Date: March 15, 2018  
To: Cumberland Planning Board  
From: Carla Nixon, Town Planner  
Subject: OceanView at Cumberland - Major Subdivision Preliminary Plan Review

Date March 15, 2018  
To Town of Cumberland Planning Board  
From Carla Nixon, Town Planner  
Subject **Major (Preliminary) Subdivision Review: Oceanview @ Cumberland. 277 Tuttle Road**

As requested, Sevee & Maher Engineers, Inc. (SME) has completed a review of the comment responses submitted for the preliminary application for a Major Subdivision and Site Plan for the proposed OceanView at Cumberland senior living community located off Tuttle Road. This submission is identified by the applicant as Revised Preliminary Subdivision Plan Submittal – Addenda-1A. The application materials received by SME were prepared by LICHT Environmental Design, LLC (LICHT), and consist of the following:

## PLAN OF Existing Conditions Survey

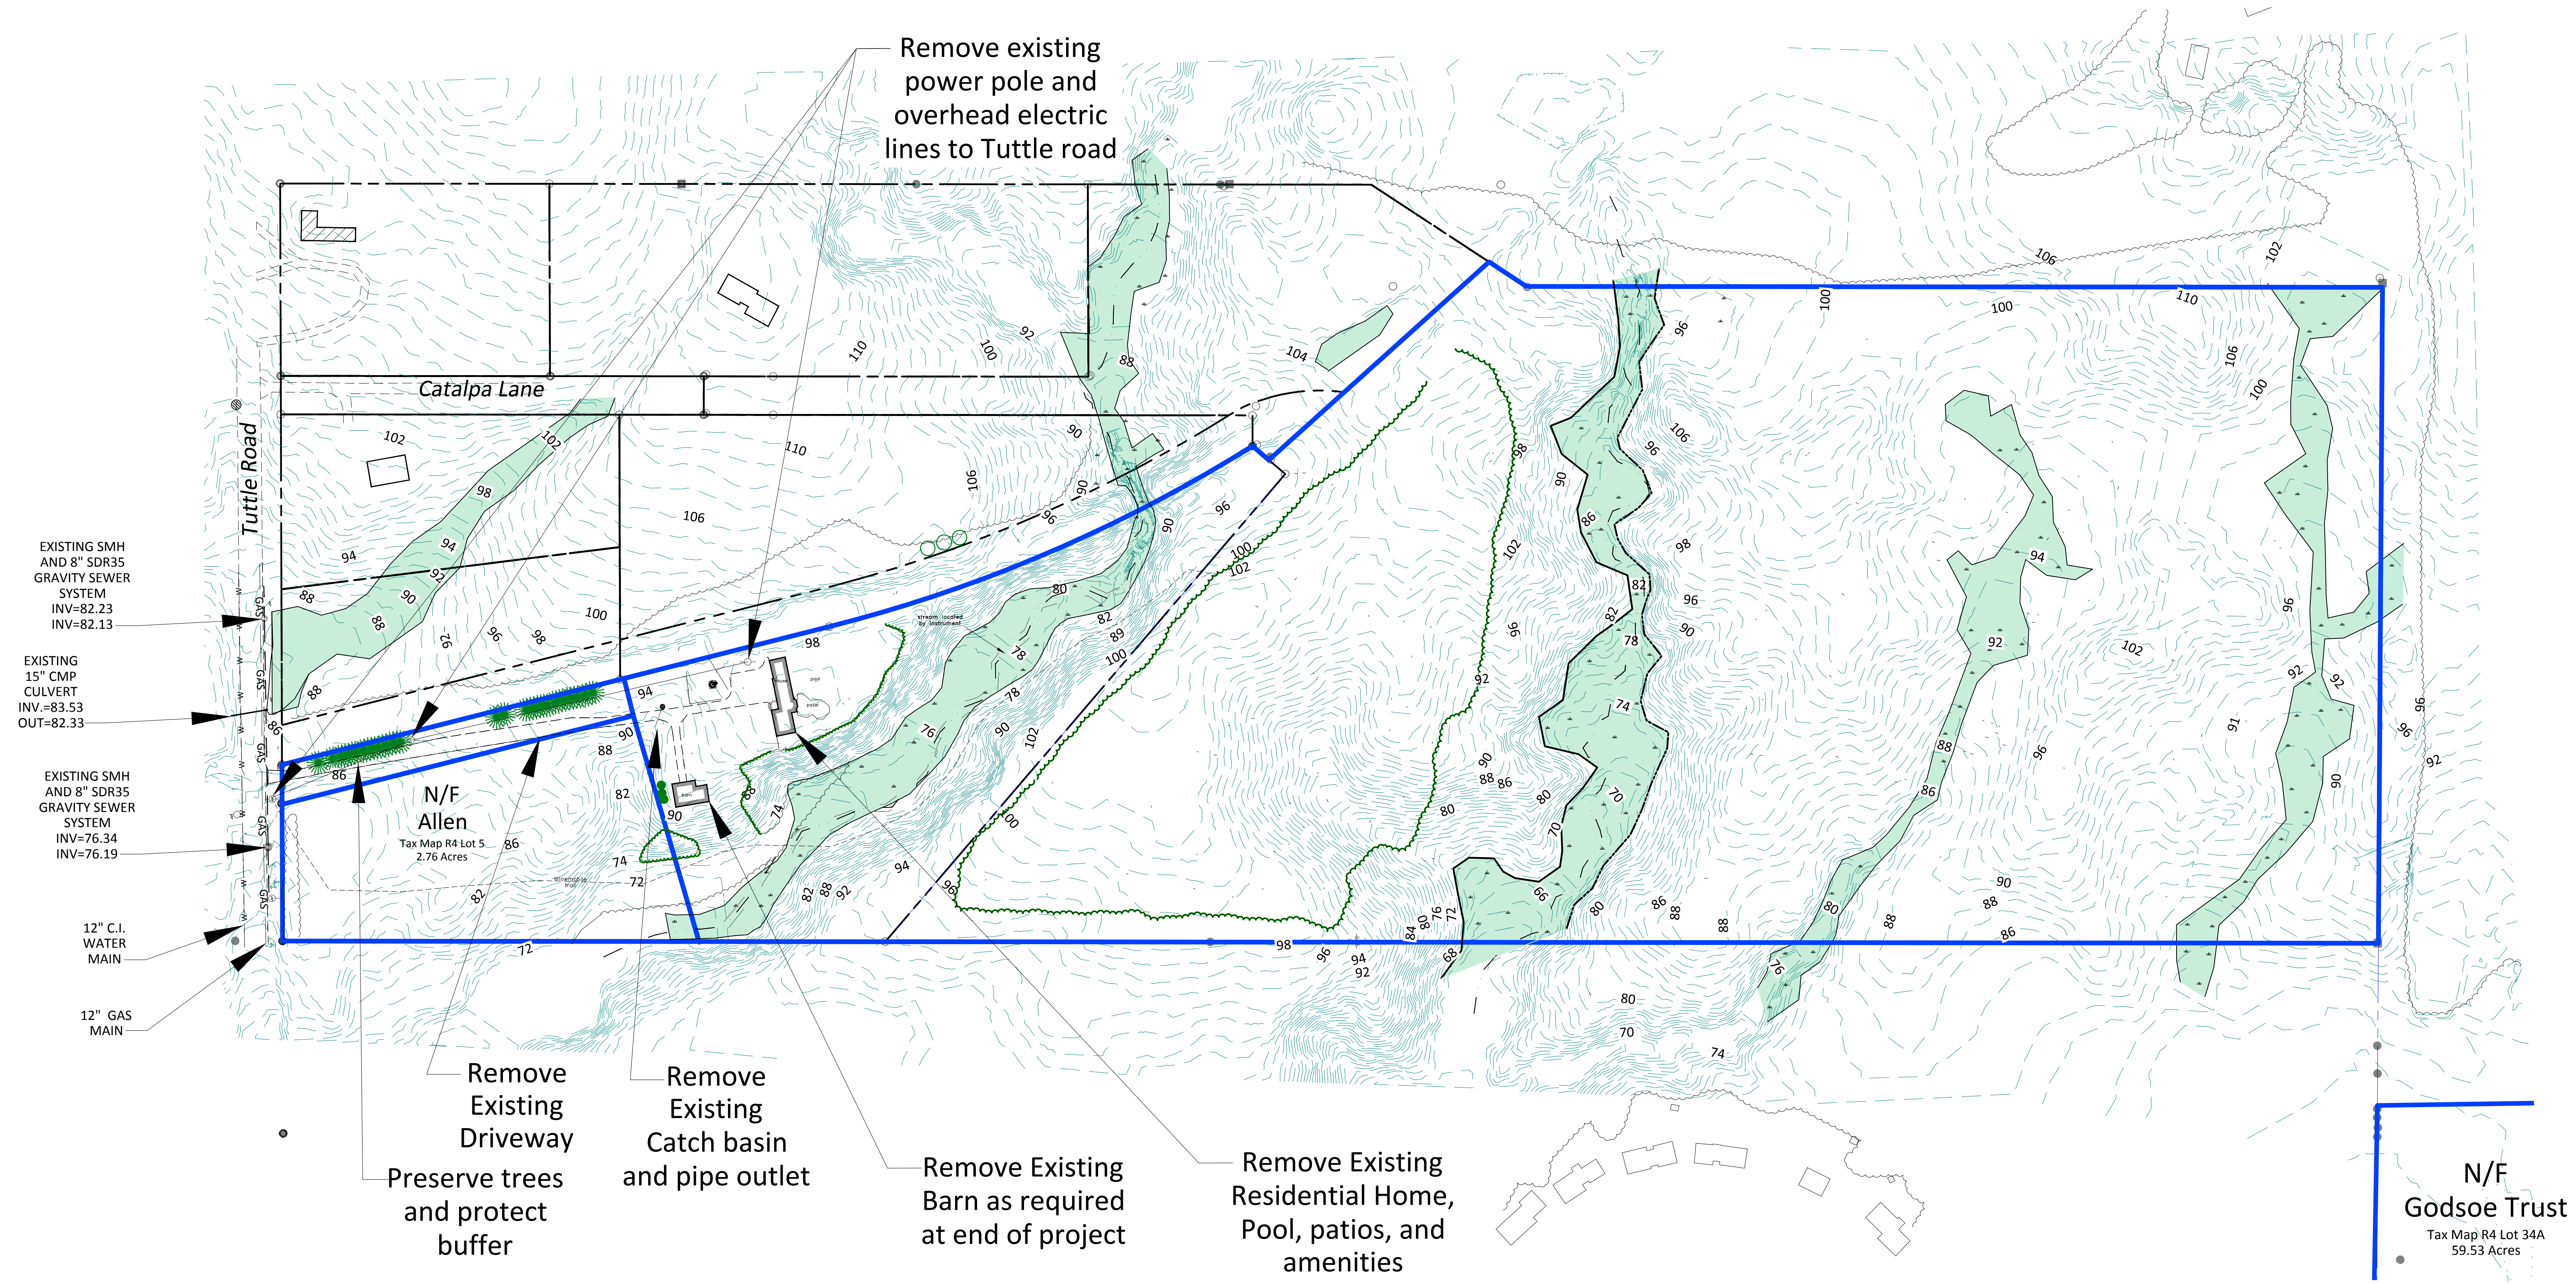
27. Topographic Site Plan by Titcomb Associates (Sheet 1 of 1) is not included in the plan set. Please add an existing conditions plan to the drawing set.

27. Topographic Site Plan by Titcomb Associates (Sheet 1 of 1) is not included in the plan set. Please add an existing conditions plan to the drawing set. *The Existing Conditions plan has been included in the revised plan set.*

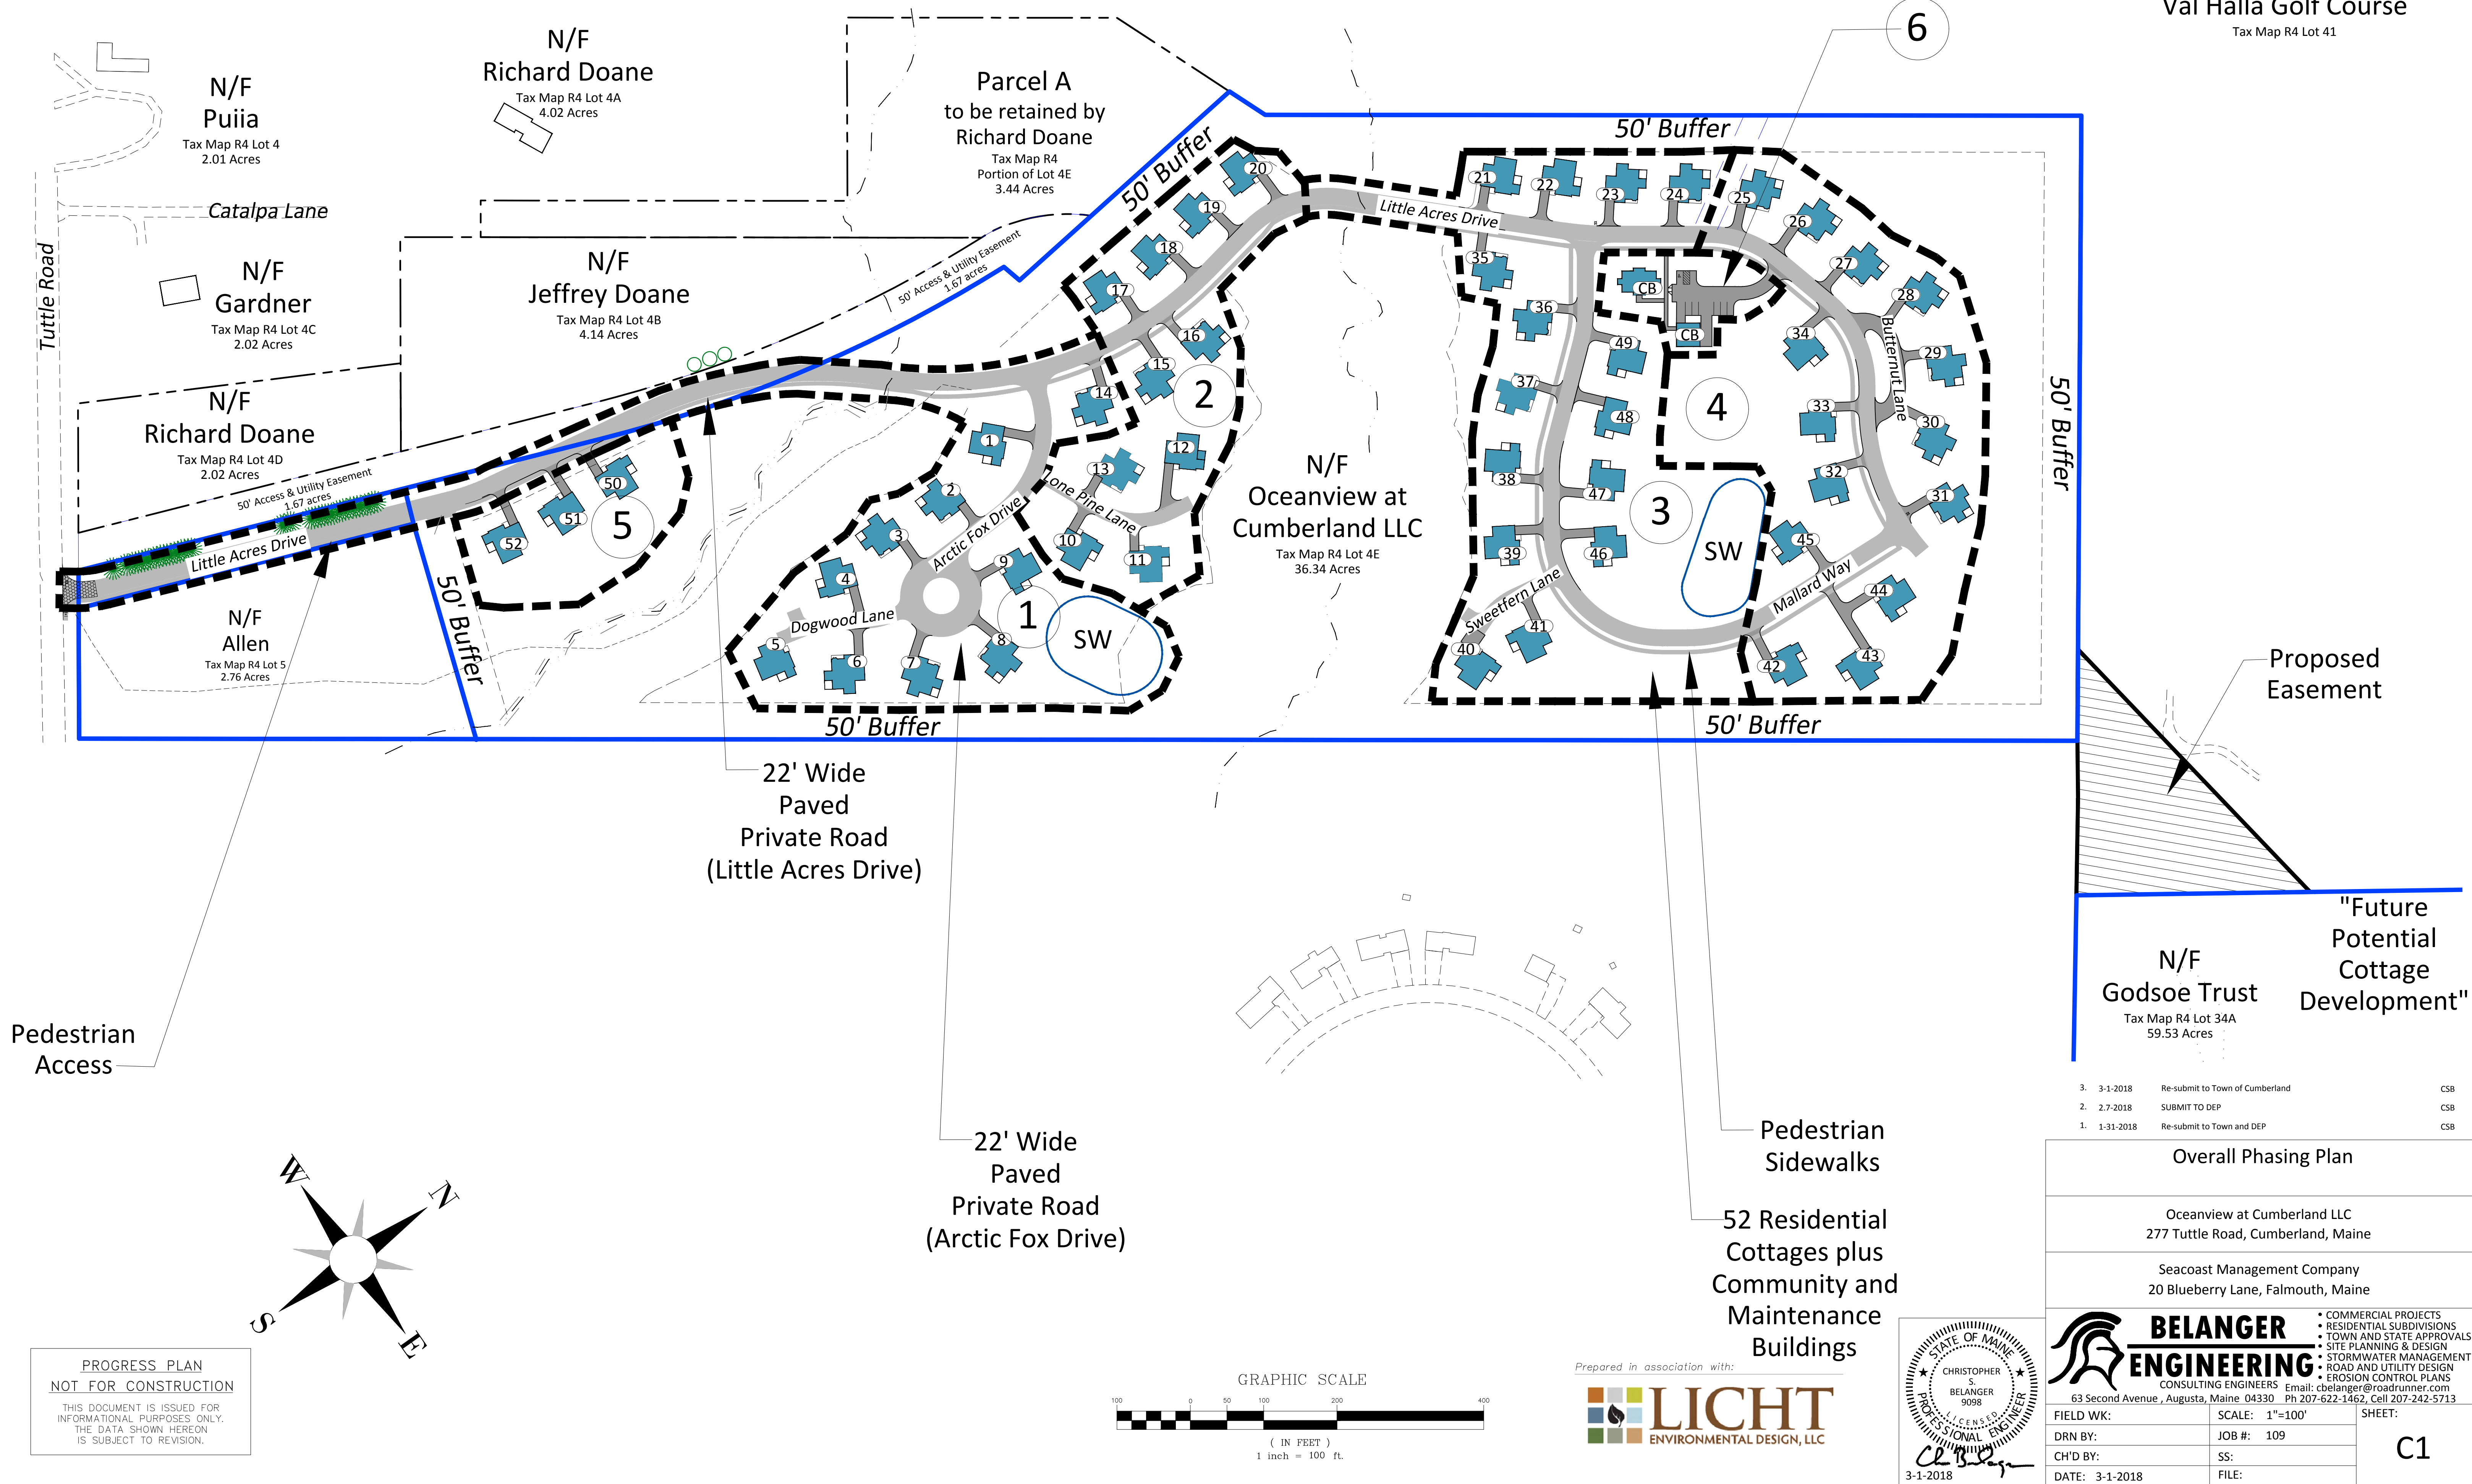
28. Overall Plan Sheet C1 references a 50-foot buffer and golf cart trails not shown on the drawing.

28. Overall Plan Sheet C1 references a 50-foot buffer and golf cart trails not shown on the drawing. *Plan C1 has been revised and is intended as an overall phasing and development plan. Refer to other plans in the drawing set for additional site information.*

FIELD WK:	SCALE: 1"=60'	SHEET:
DRN BY:	JOB #:	C2
CH'D BY:	SS:	
DATE: 3-1-2018	FILE:

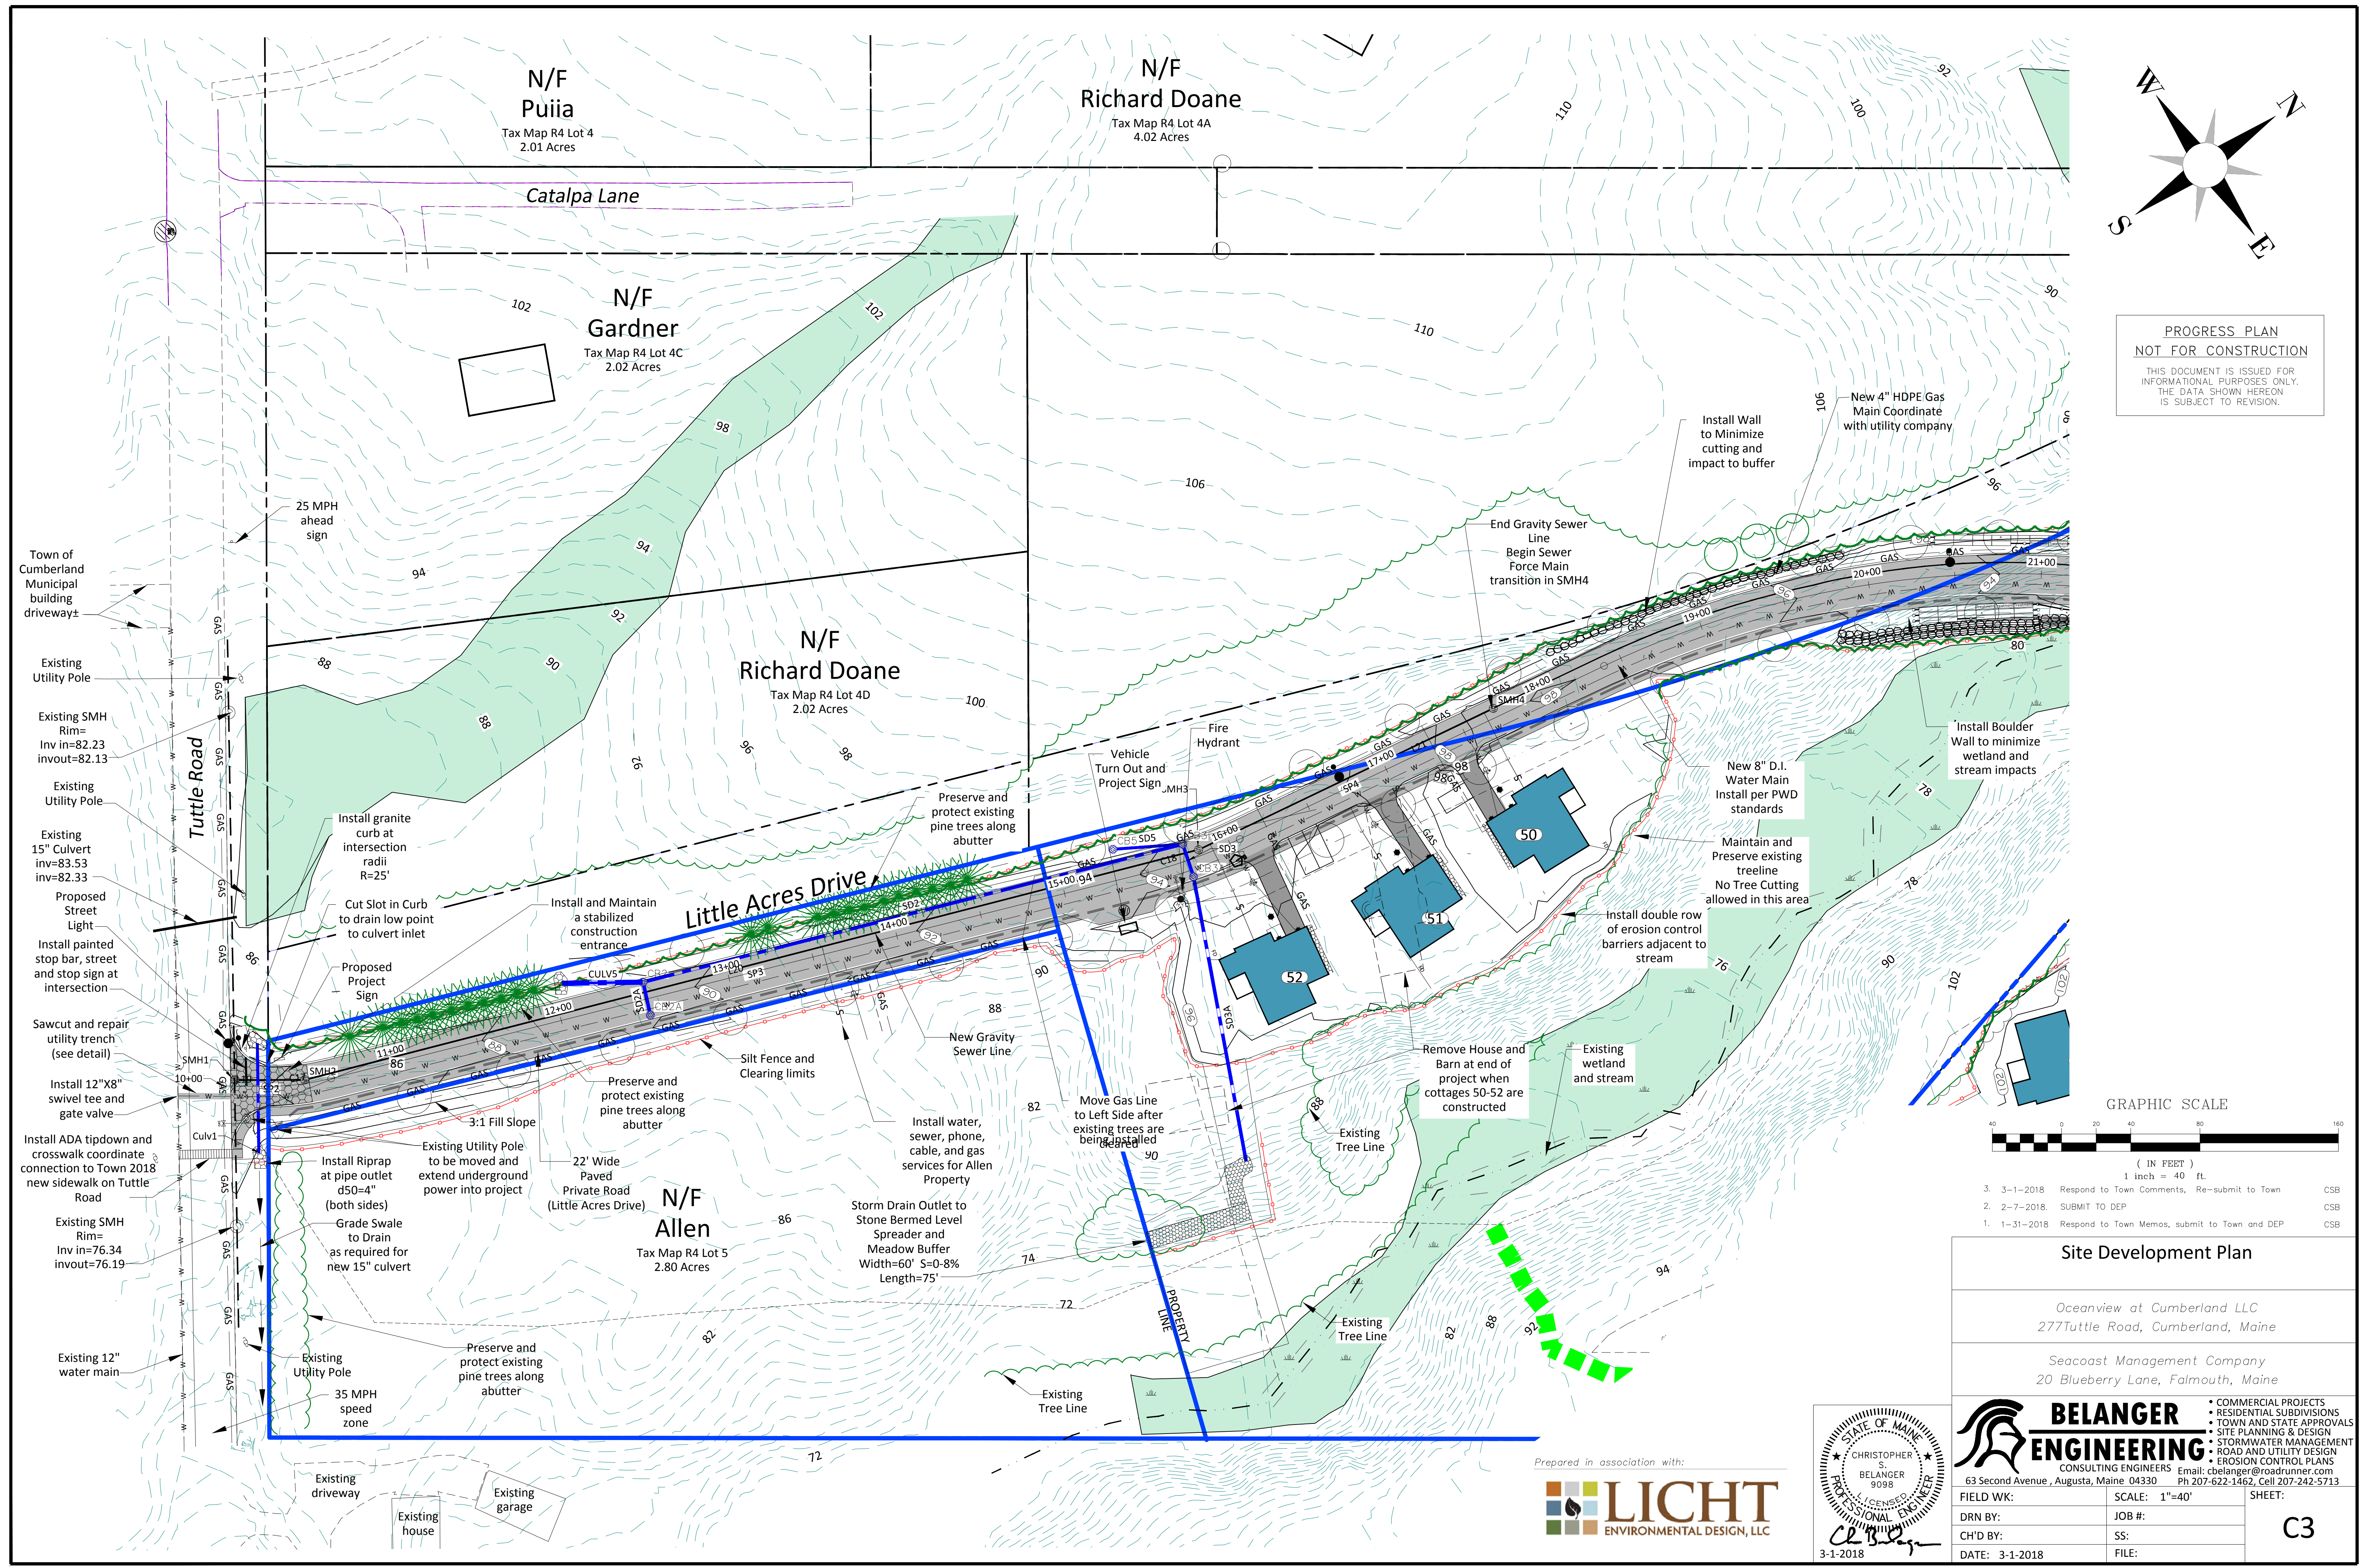
4. The cover letter outlines 11,200 sf +/- of proposed wetland impacts. Plan sheet C2 outlined 12,700 sf of proposed wetland impacts. Please clarify.

4. The cover letter outlines 11,200 sf +/- of proposed wetland impacts. Plan sheet C2 outlined 12,700 sf of proposed wetland impacts. Please clarify. *The revised submission has been updated to reflect 12,700 sf of wetland impacts, consistent with the DEP-NRPA Tier-1 application.*
